TS-SSC 90-076
REVISED

Instrumentation for 40 mm Long Magnets

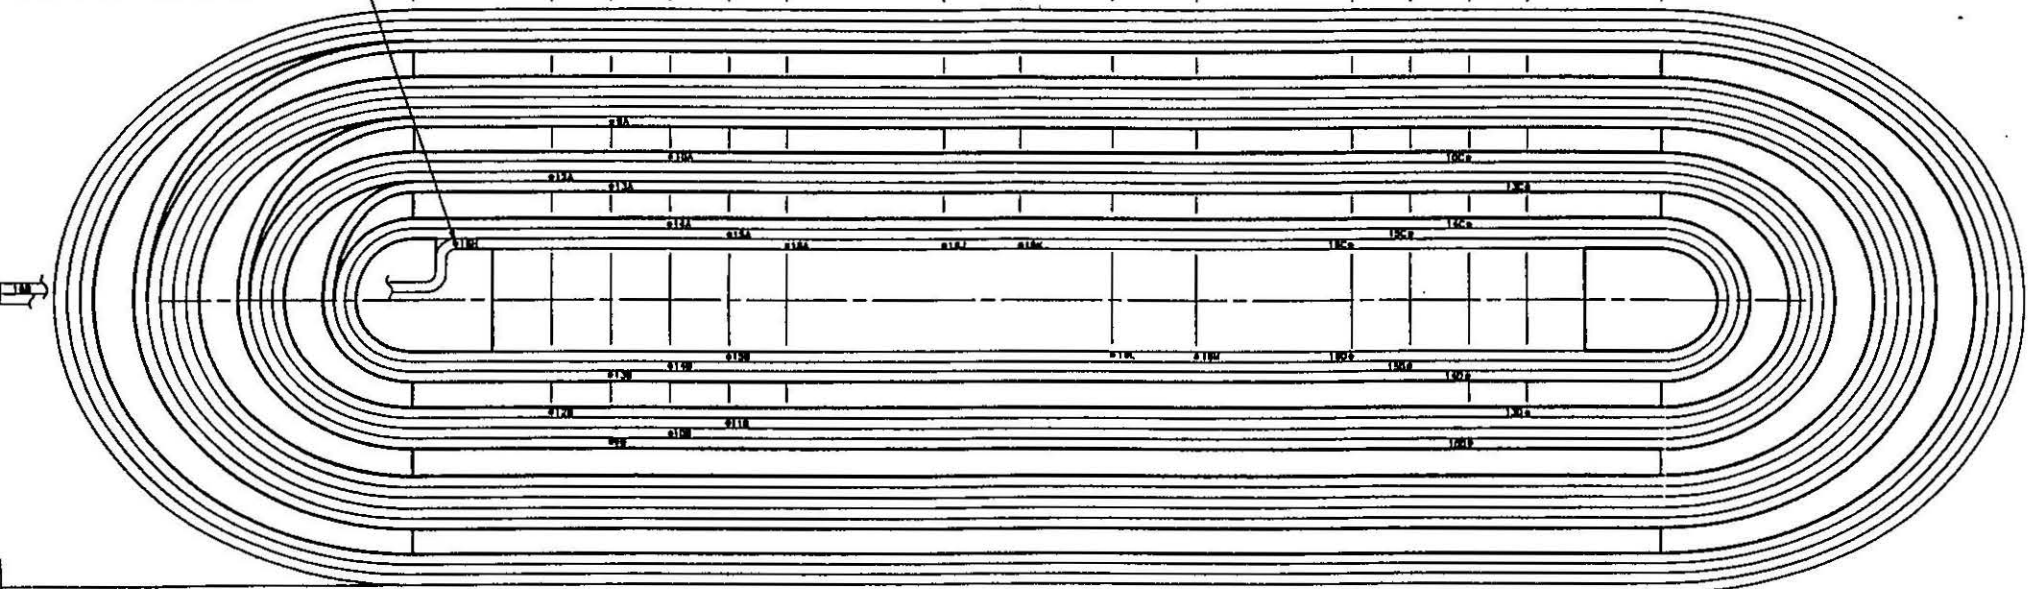
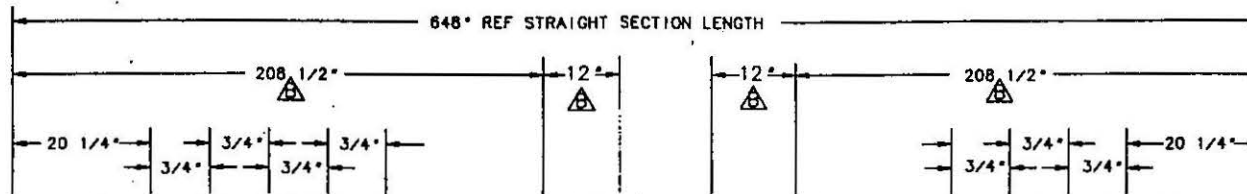
Figure 1 (from drawing #102-MC-263900) shows the voltage tap arrangement. The taps in the middle of the pole turn (16J, 16K, 16L, 16M) will be put only on DC0304. John Tompkins has requested that the drawing be revised to show explicitly the distance between the end of the coil straight section and the tap 16H and the corresponding outer coil tap 20A.

A	C. ADDED 6 NEW VOLTAGE TAPS		
A	DELETED FOUR TAP LOCATIONS AND	R.DIXON	10/82
	ADDED 2. ADDED 208 1/2", 12" DIMS.
